January 20, 2015

OBJECTION: FOUR FOREST RESTORATION INITIATIVE
FINAL ENVIRONMENTAL IMPACT STATEMENT AND DRAFT RECORD OF DECISION

Project name: Four Forest Restoration Initiative

Figure 1. Locations of wildlife movement corridors and VSS 4,5,6 retention stands located therein.

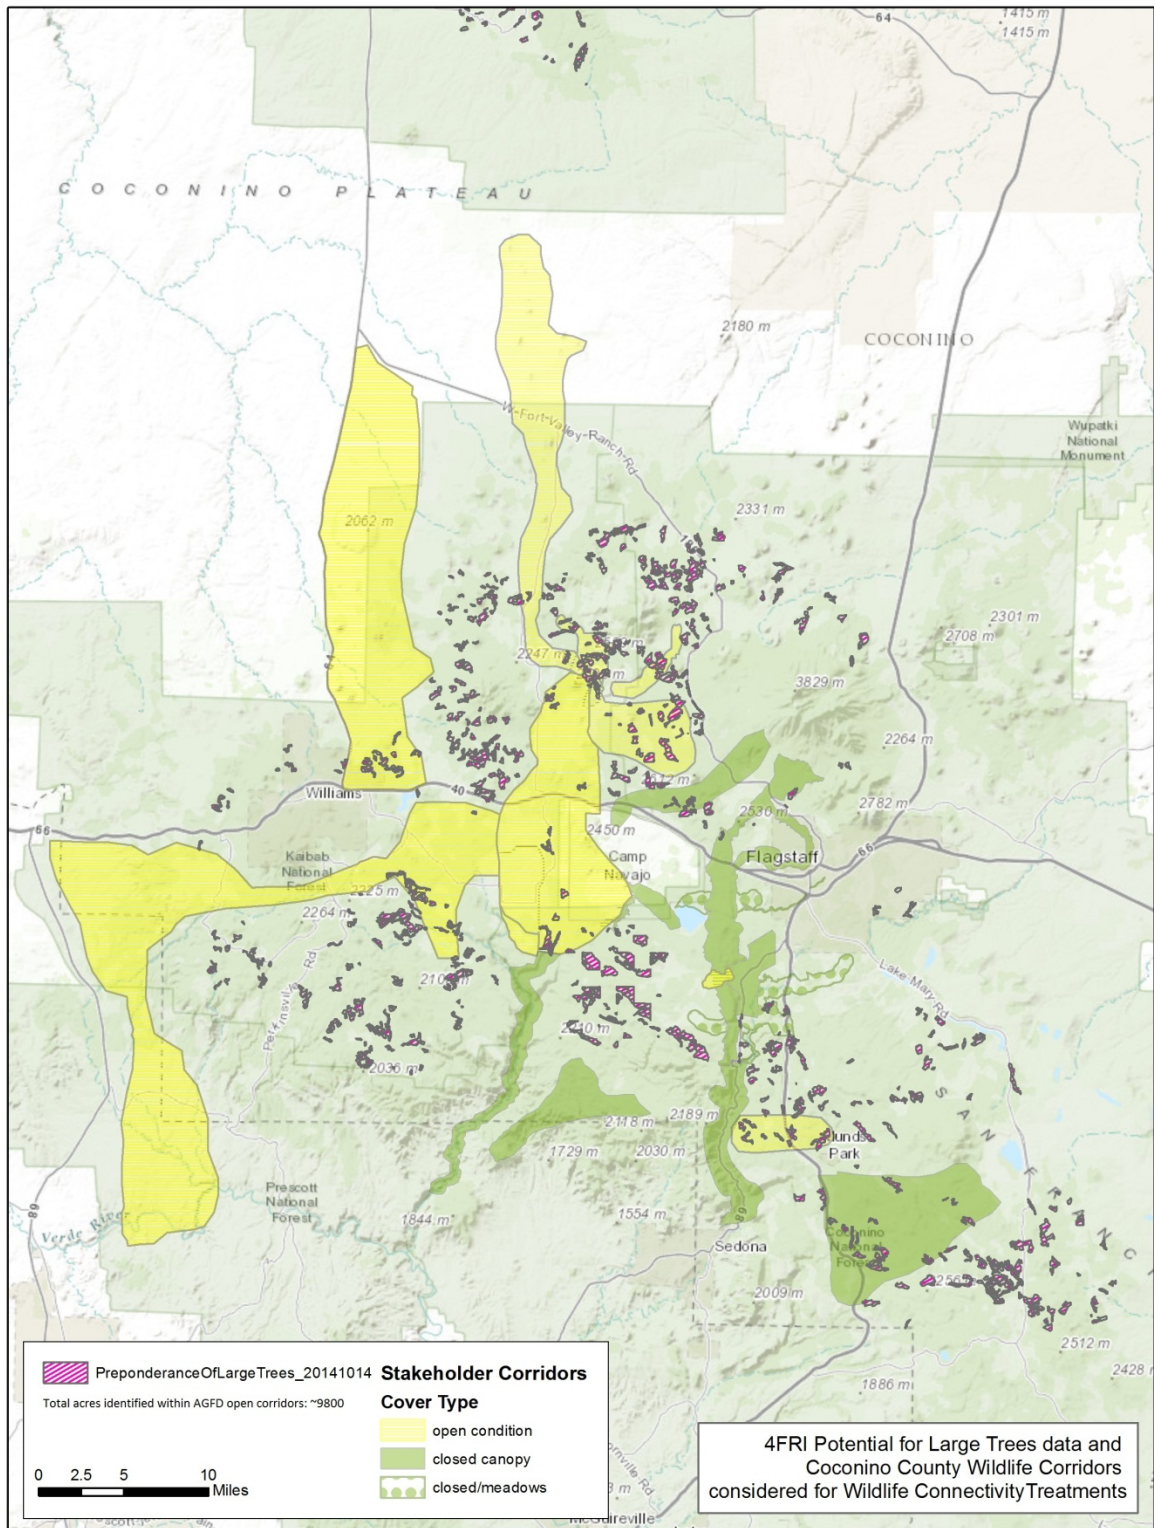
Treatment elements intended to benefit grassland species were vetted through the 4FRI stakeholder group and included in the initial treatment design (DEIS). Unfortunately, the selected Alternative C did not carry these forward in full. Approximately 9,800 acres of stands targeted for retention of mature/old-growth and large, young trees (VSS 4-6) and higher levels of canopy cover fall within grassland species movement corridors identified in the 2011 connectivity assessment (Figure 1). Within those stands, the Department has identified approximately 2,500 acres that represent potential high-priority areas for creation or enhancement of connectivity for pronghorn and other open-canopy species. Examples of such areas are given in Figures 2-3.

We are concerned that strict implementation of the Alternative C treatment design will compromise our ability to meet important conservation objectives for grassland wildlife and miss opportunities to leverage work being done under 4FRI. Where large tree retention objectives overlap with identified grassland-species movement corridors, we recommend adding language to the ROD and Implementation Plan that provide flexibility for more intense mechanical treatment under limited and clearly defined circumstances. This would allow removal of conifers from encroached meadows, restoration and connection of forest openings, and creation of travel corridors through stands with high tree densities. Our expectation is that few, if any of these modifications would impact stands composed of mature or old-growth trees, instead falling into those with a preponderance of large, young trees. It's important to note that delineation of retention stands was based on USFS stand exam data, which are relatively coarse with respect to the scale at which mechanical treatment would be used to create/modify movement corridors.
